NUMBER: 14-004-22 REV. A

GROUP: 14 - Fuel System

Updated Fuel Filler Cap and Fuel Filler Tube

2021 (JL) Jeep Wrangler

Fig. 1
Upper Fuel Fill Tube

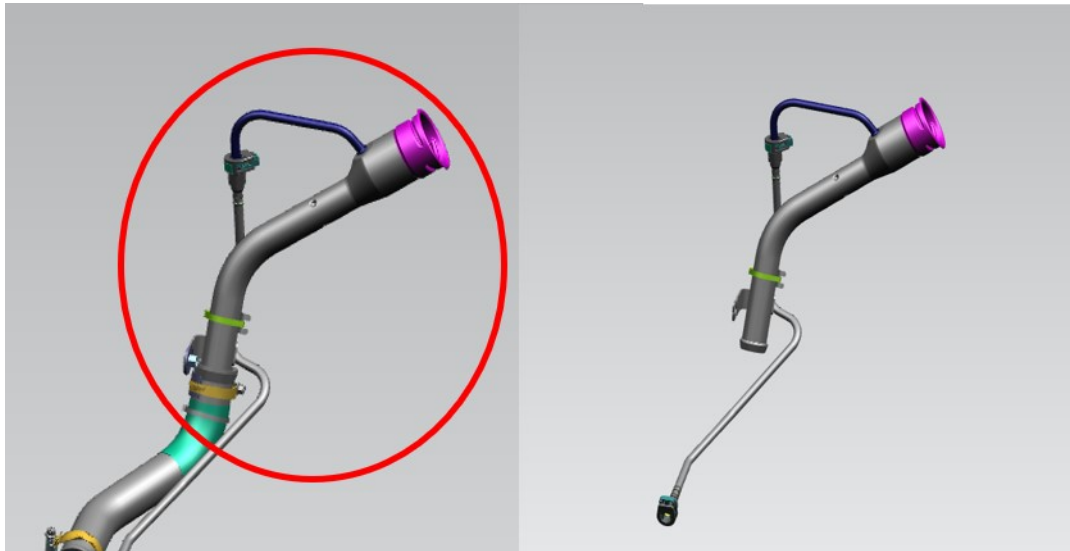
1. Remove and discard the fuel filler cap from the upper filler tube (Fig. 1) .
2. Install the new fuel filler cap on the filler tube (Fig. 1) .
